An Updated Portfolio Present Value Cost Analysis of the Site C Project

October 2017

The purpose of this Report is to provide the BC Utilities Commission with information relevant to its Inquiry into the Site C Project.

Figure 1. Sample portfolio output from 2013 IRP (above) and Site C Inquiry Submission (below)

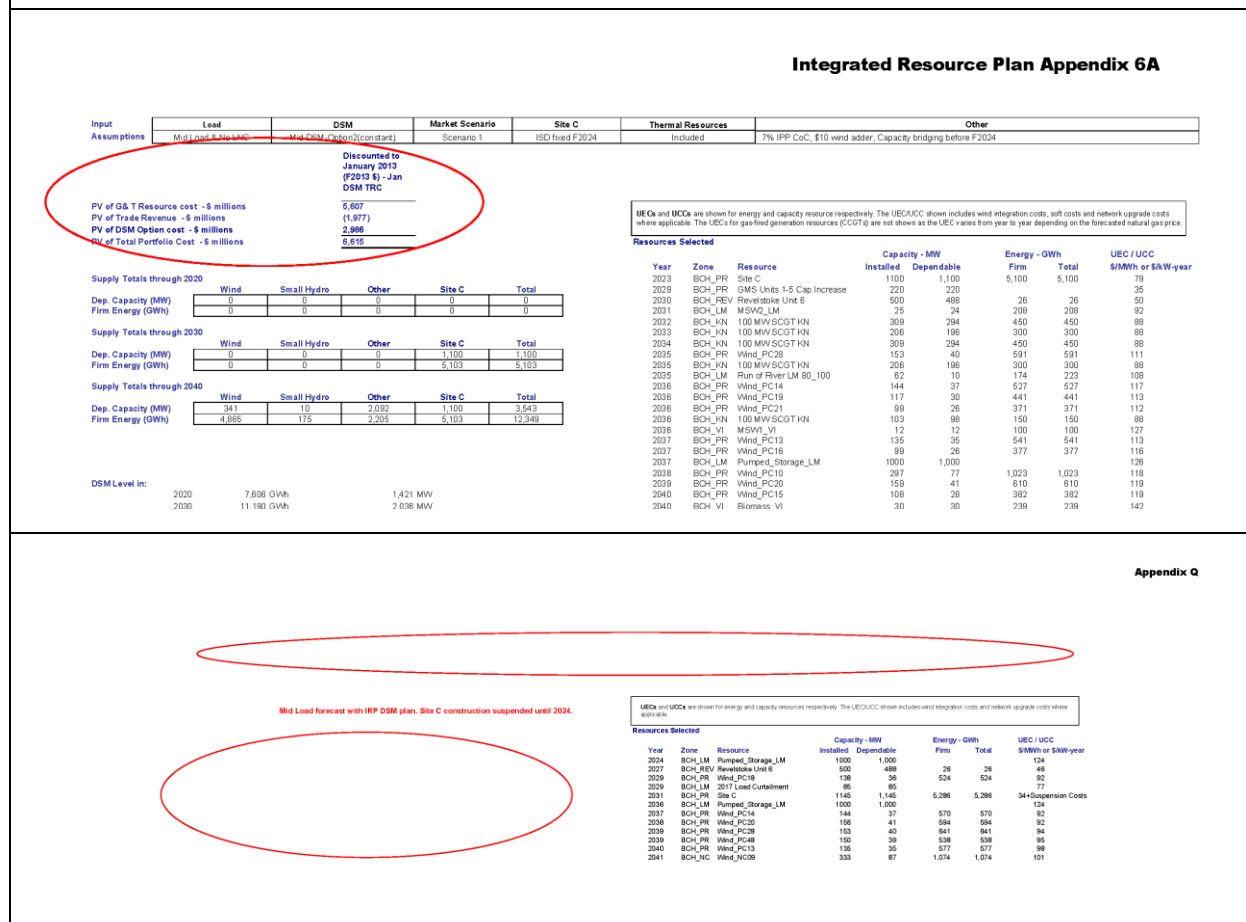
While BC Hydro suggests that it has carried out a present value analysis comparing portfolios with and without the Site C Project, **nowhere in its Submissions does BC Hydro present results or the supporting detail of that present value analysis**. In Appendix Q of BC Hydro's Submissions, System Optimizer outputs are presented for 11 scenarios, but (unlike the similar outputs presented in the 2013 IRP) the key result of each one — the present value of its incremental costs — is not shown.¹ Figure 1 compares the System Optimizer outputs presented in the Integrated Resource Plan (above) and the present inquiry (below). The actual present value costs are conspicuously absent from the outputs provided to the Commission.

Thus, while BC Hydro affirms that it has carried out a System Optimizer portfolio analysis, it has **deleted from the scenario outputs the specific results that permit an economic comparison amongst the options.** These omissions undermine the credibility of the Submission, as the missing data are essential to understanding the implications of the options, as required by the Terms of Reference.

Figure 2. Sample portfolio output from 2013 IRP

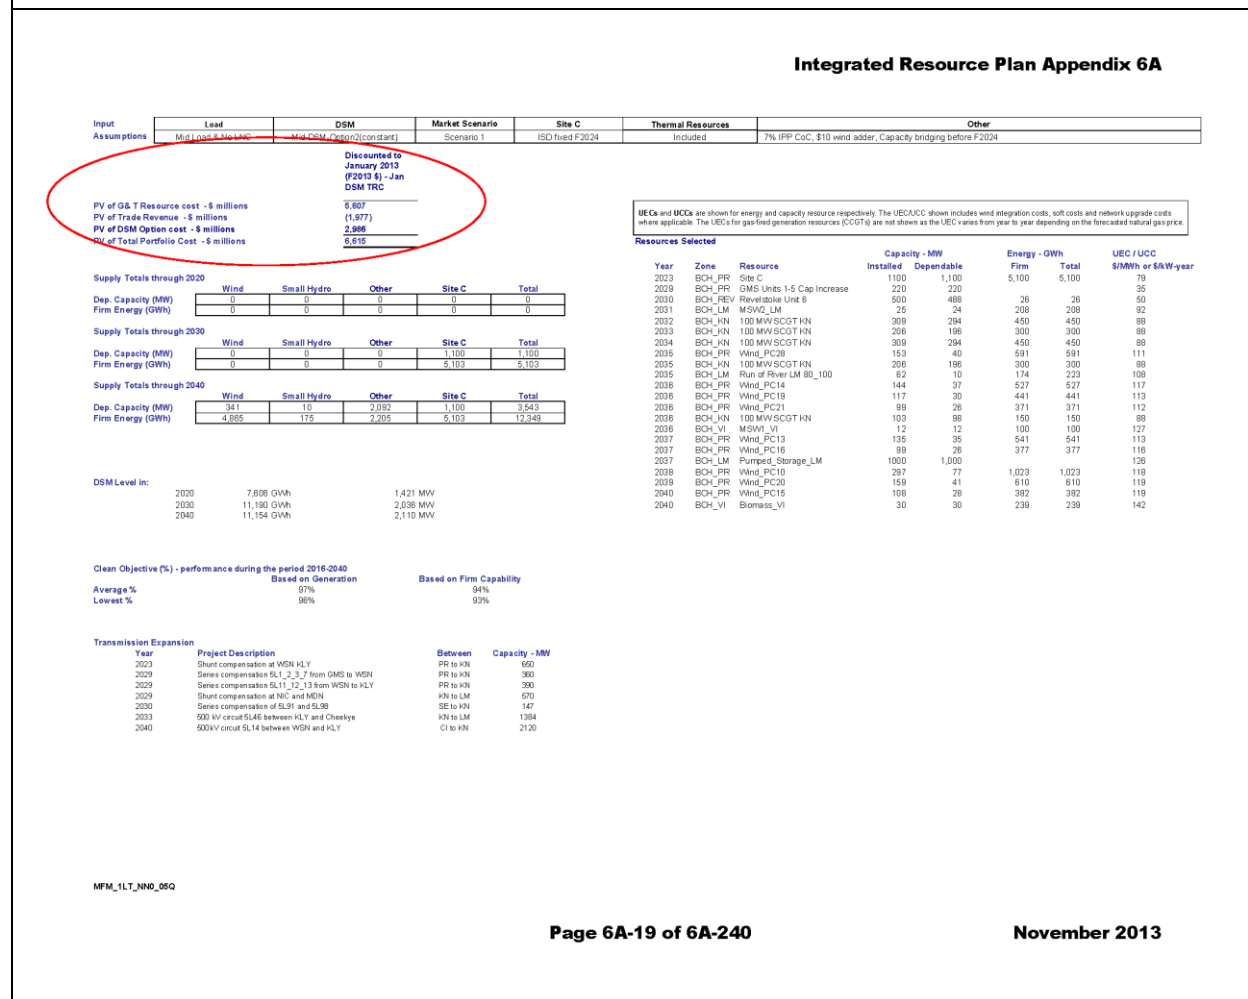
The presentation of portfolio results in Appendix Q is similar to that of the 2013 IRP, but with several very important details omitted. Figure 2 presents a sample output from the portfolio analysis in the IRP. Across the top, it defines the scenario and portfolio under study. On the right, it lists the resources that System Optimizer selected. And in the upper left, it shows the

In the IRP, this last value – the total present value of the portfolio – was the measure used for the economic comparison between portfolios. For example, Table 5, taken from Appendix 6A of the IRP, shows how the scenarios and their present values were used to compare the costs of pairs of portfolios, with and without the Site C Project.²²

Figure 3. Sample portfolio output from 2013 IRP (graphs)

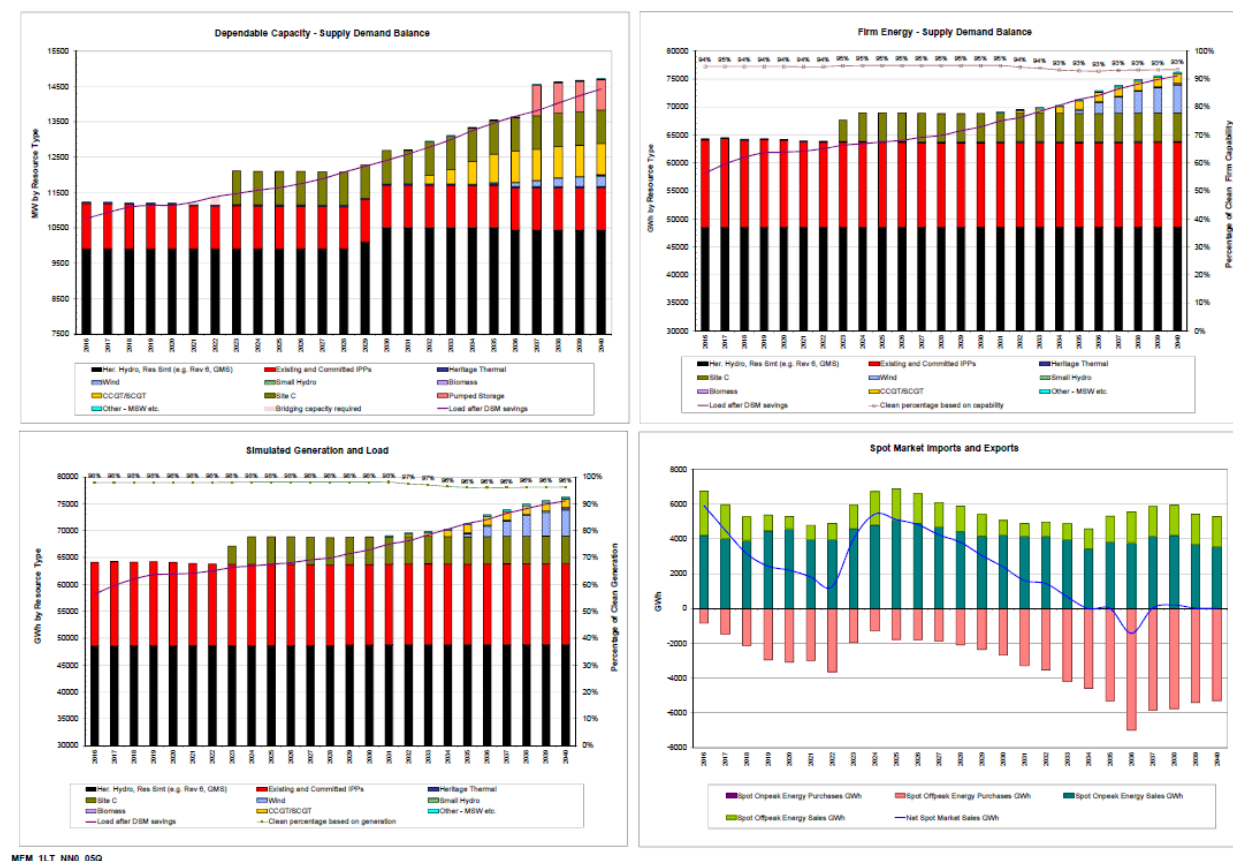
While the year-to-year energy and capacity balances were not provided in tabular form, they clearly were calculated in order to generate these charts.

As seen in Figure 3, the portfolio outputs in the 2013 IRP went to F2040, although the load forecast and the Base and Contingency Resource Plans only went to F2033. Clearly, some sort of load forecast was used to generate these scenarios but, to the best of our knowledge, it was never made public.

Figure 4. Sample portfolio output from BCUC Submission

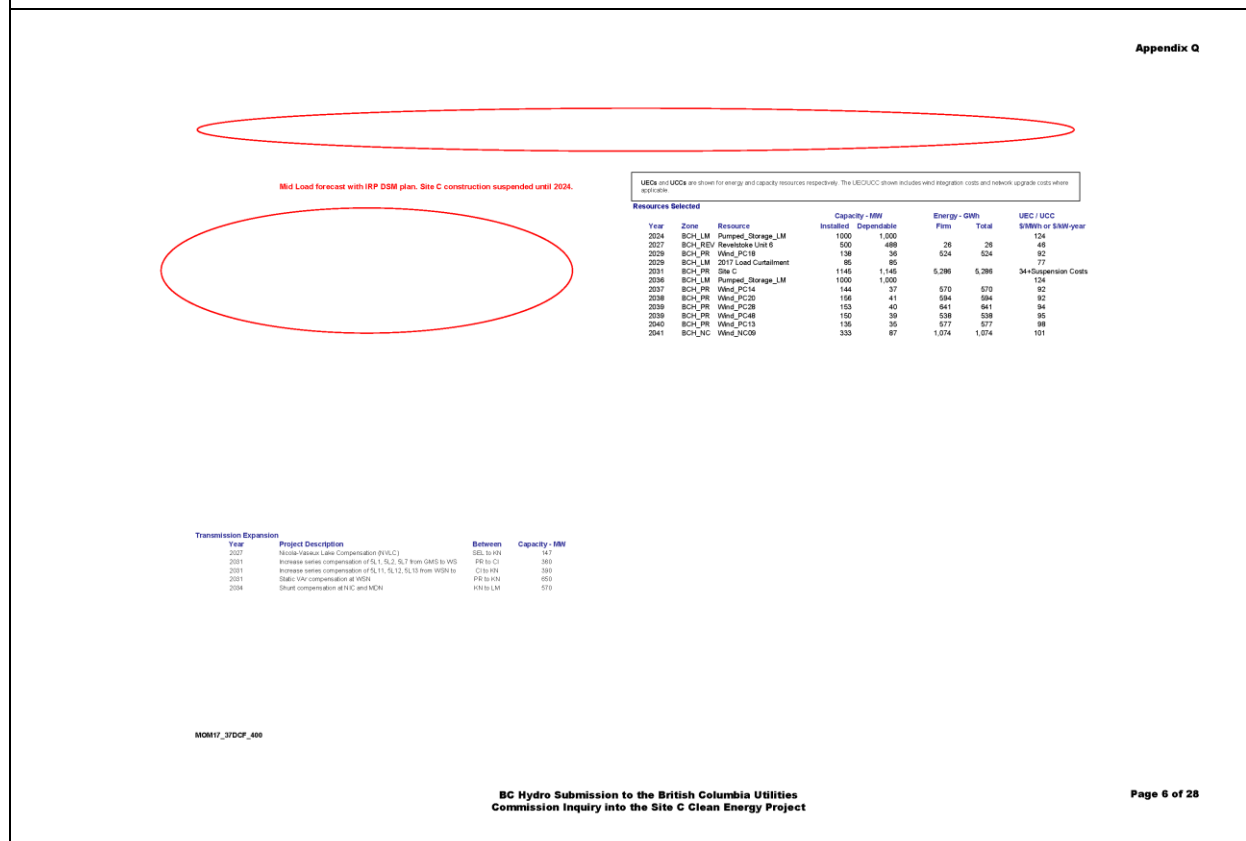
Appendix Q provides output sheets similar to those presented in the IRP, and were clearly generated by the same System Optimizer program. However, there is one very important difference: **in Appendix Q, the present value costs of each portfolio are omitted, as seen in Figure 4.** The detailed portfolio and scenario definitions, found across the top of the page in the IRP portfolios (Figure 2), are omitted as well.

Thus, while BC Hydro affirms that it has carried out a System Optimizer portfolio analysis, **it has deleted from the scenario outputs the specific results that permit an economic comparison amongst the options.** These omissions undermine the credibility of the Submission, as the missing data are essential to understanding the implications of the options, as required by the Terms of Reference.

Figure 5. Forecast DSM energy savings in BC Hydro Rate Impact Analysis

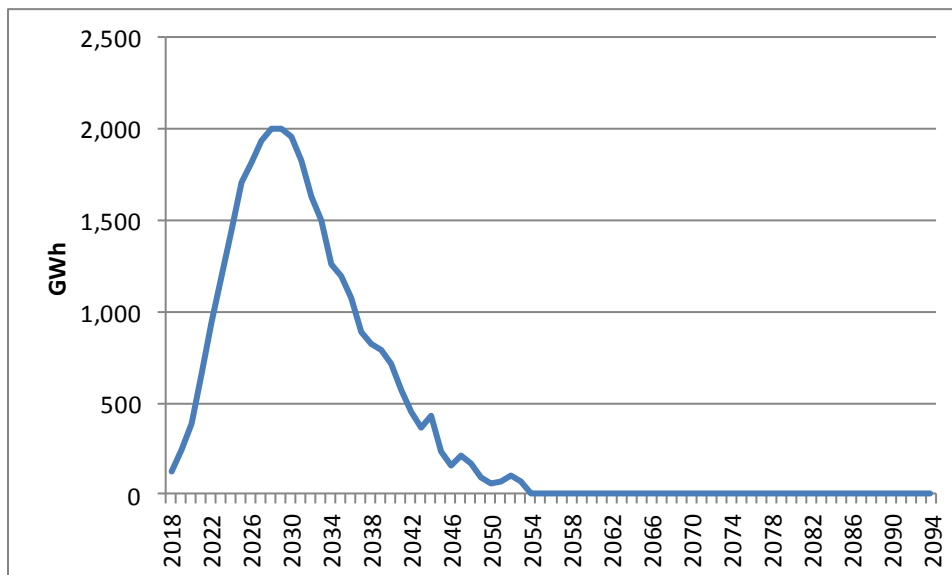
This analysis relies on a number of surprising assumptions, several of which will be examined in detail below. First, it forecasts zero increase in energy sales from F2047 to F2094. Second, DSM additions fall to zero in F2054, as seen in Figure 5.

Figure 6. BC Hydro Rate Impact Forecasts

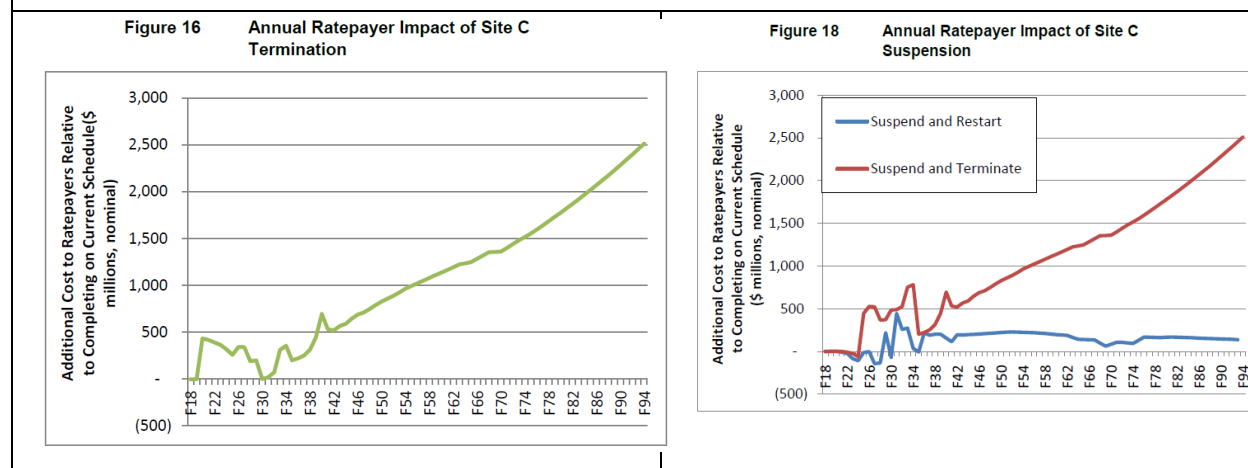
Review of the structure of this Summary page reveals that this line is the primary driver behind line 8 (“Estimated Total Change in Revenue Requirement”), which is in turn the primary driver behind the “Estimated Incremental Impact of Future Rates” and the “Estimated Incremental Cumulative Rate Impact”. It is this last line that is plotted in the dramatic Figures 16 and 18, reproduced below, which purport to demonstrate the catastrophic rate impact of termination or suspension of the Site C Project.

How was this “Increase in the Cost of Energy” derived? In an Excel spreadsheet, the formulas for the cells that make up this line would normally indicate how they were derived. **However, in this spreadsheet, there are no formulas in the “Increase in the Cost of Energy” row.**
